DEVIATION REQUEST AND DECISION FORM

Project Name : SF1819: Lorson Ranch East Filing 2

A deviation from the standards of or in Section **El Paso County Standard Drawing of the Engineering Criteria Manual (ECM) Detail SD 4-20**, is requested.

Exhibit showing Chemical
Grout Locations on Lorson
Ranch East Filing 2

- Sinking Road/Sidewalk - area to be treated with chemical grout
- ADA Ramp/Sidewalk Issues
- Missing Signs, Stop and Street Names
- ▨ Mill and Overlay
- ▨ Stand alone patches, All patches WILL go the the centerline seam

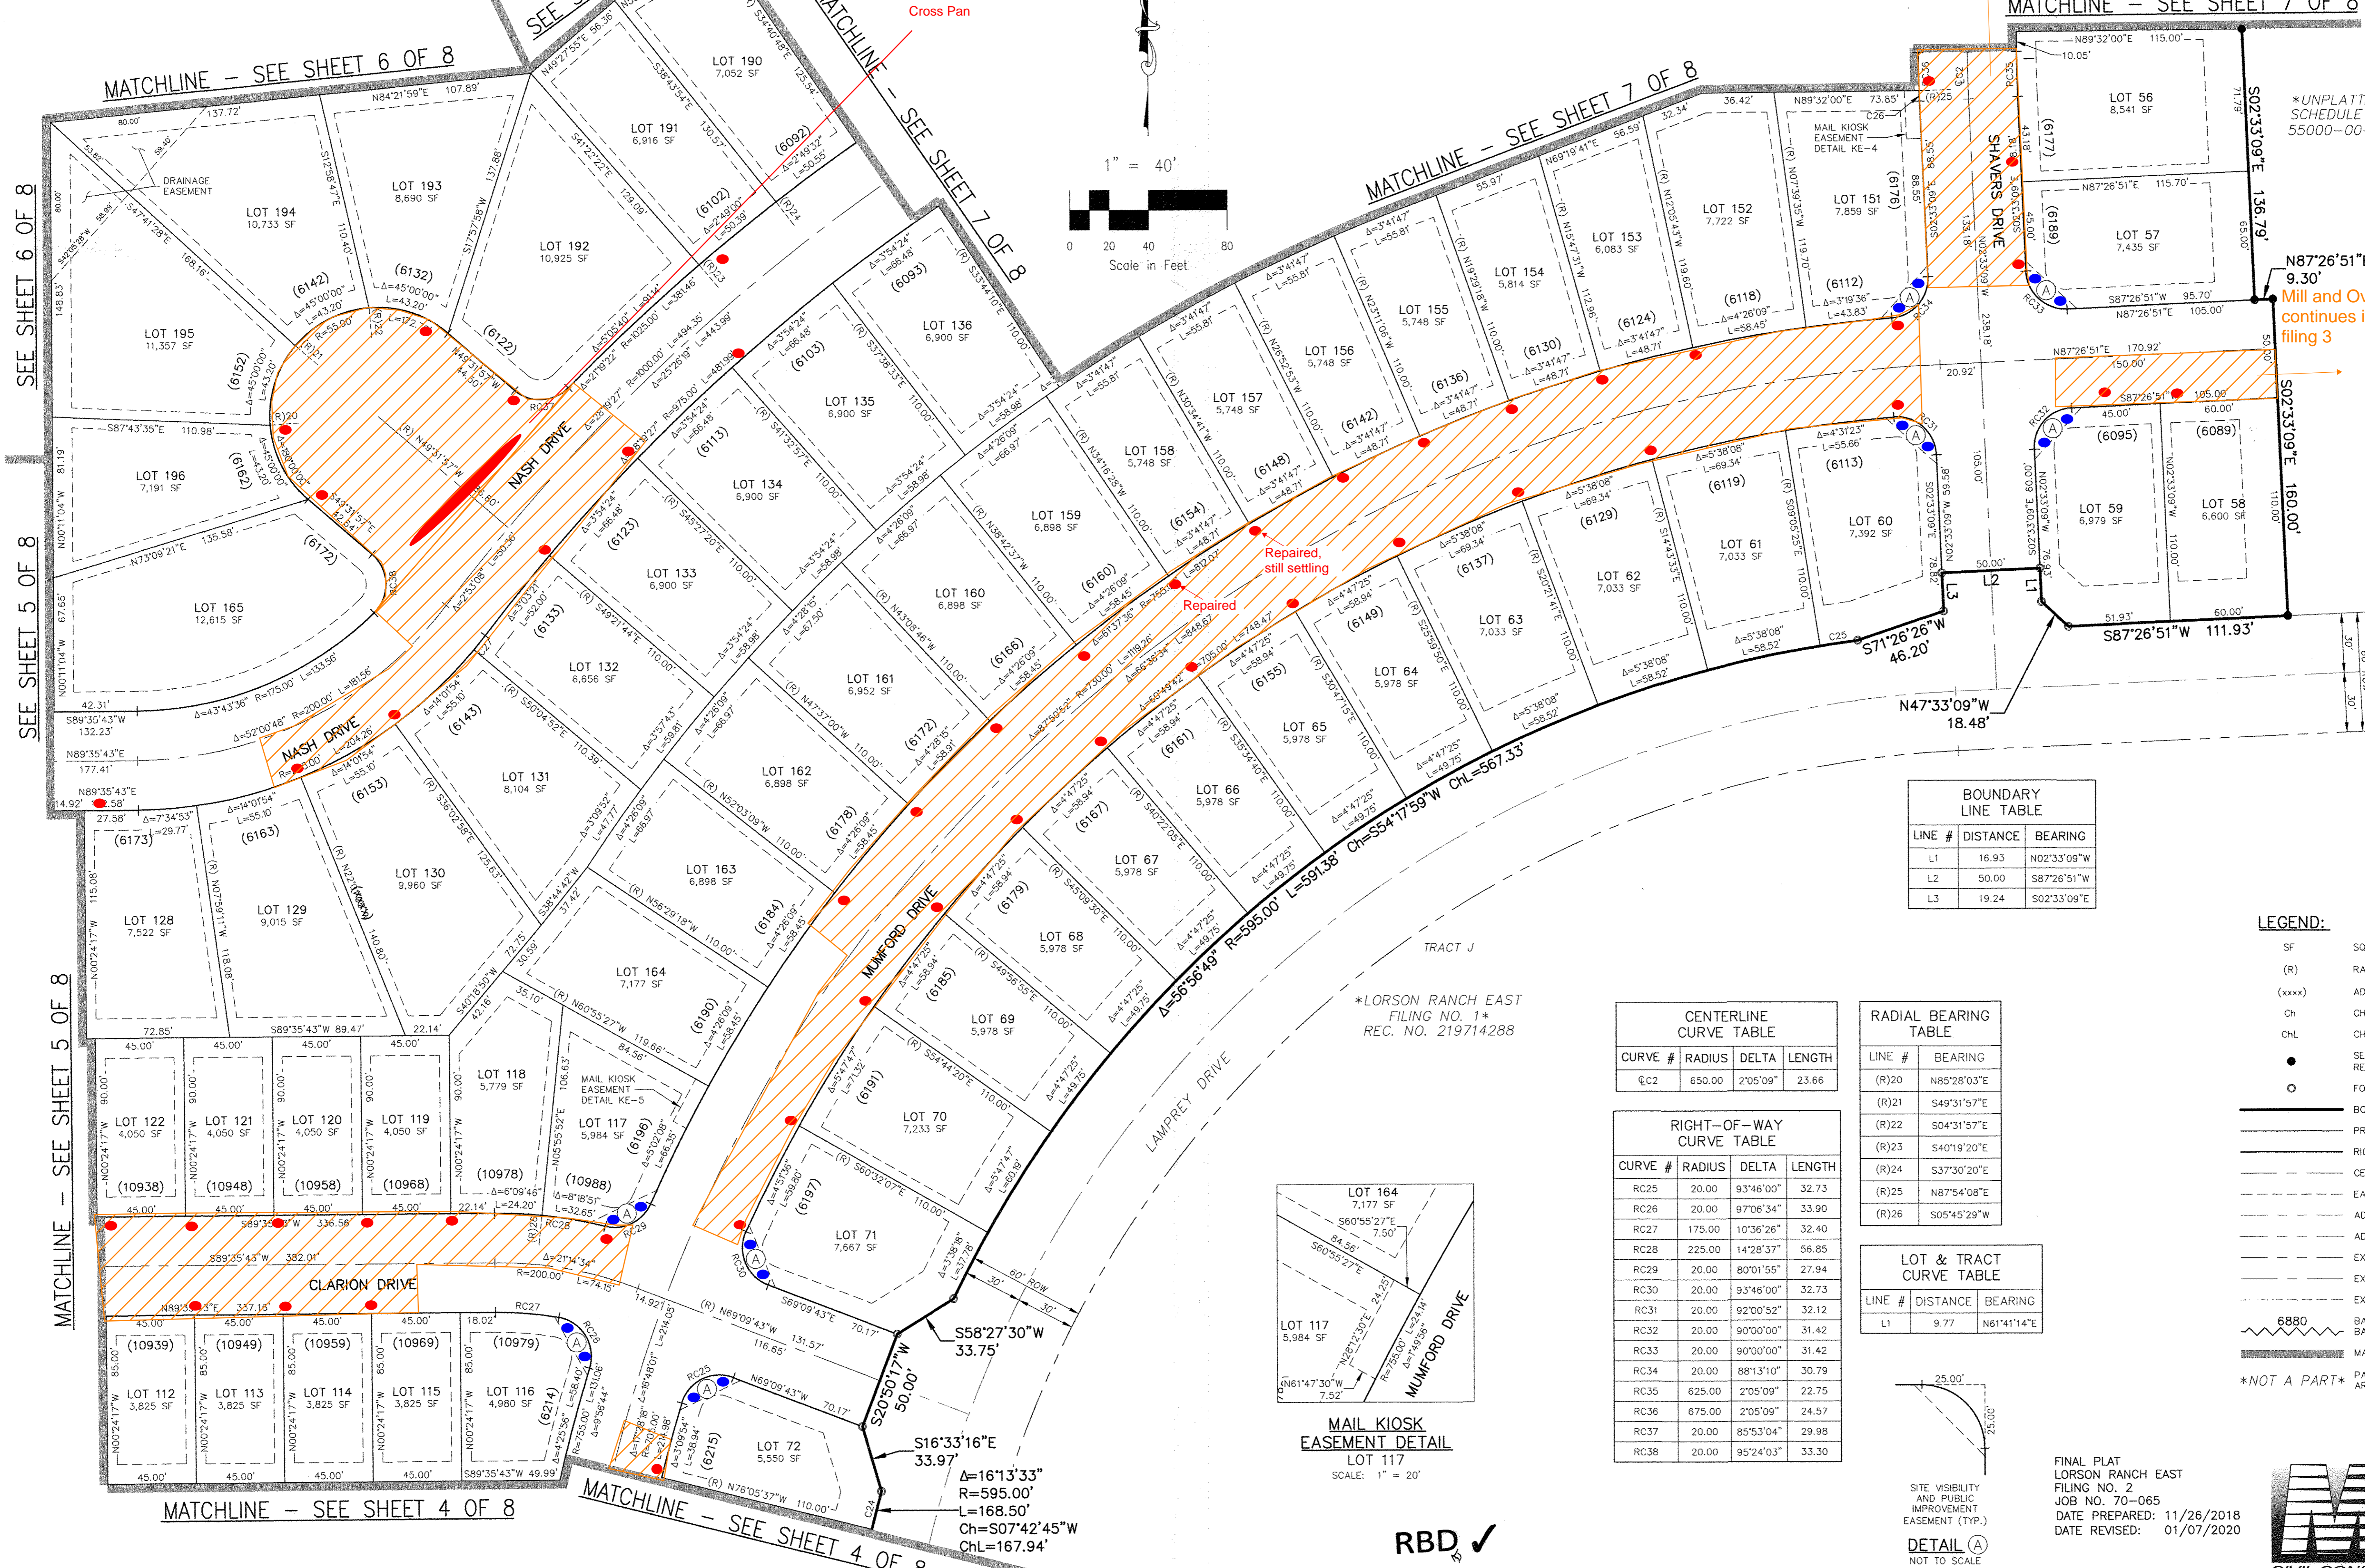
Deviation request for the use of the chemical grout to stabilize the soils within the roadway and utility trenches where settlement and distress were observed and to lift and relevel pavement, concrete flatwork, and stormwater catch basins. The deviation request is requested for Lorson Ranch East Filing 2 (File# SF1819)

The chemical grout should initially be injected approximately 4 feet on center within the utility trenches through a 1/2" injection rod advanced to a depth no greater than 4 feet below land surface (bls) through 5/8" diameter drilled holes. After an initial stabilizing injection volume that will be determined on a case-by-case basis, the injection rod tip will be raised to approximately 1.5' to 2' bls or within 0' to 1' ft bls of the base of the cement-treated subgrade (CTS) to lift and relevel the concrete slabs or pavement. When being utilized to relevel installed stormwater vaults, concrete sidewalks, or concrete curbs, the material will be injected directly beneath the concrete. The elevations of the pavement/slabs should be monitored continuously during the chemical grouting process.

please discuss whether roadway load capacity is impacted or still met by the use of this product.

Additionally, address the lifespan of the product and provide the specific product information for the proposed products listed above.

lastly, please provide the details of the 2-year warranty. What does it cover, who are the contacts should issues occur. Is there a contract # that is to be referred to if calling on the warranty is needed etc.

FYI. The following conditions of approval will be added by staff upon approval:
-As-Built drawings shall show the locations where the chemical grout was applied.
-A Notice to Proceed from EPC is required prior to the installation of the chemical grout.
-EPC inspections staff shall be present at each application of the chemical grout.
-Work a ROW permit shall be obtained for each subdivision that is currently in Preliminary Acceptance.
-An amended SIA with updated surety is required for subdivisions seeking Preliminary Acceptance.
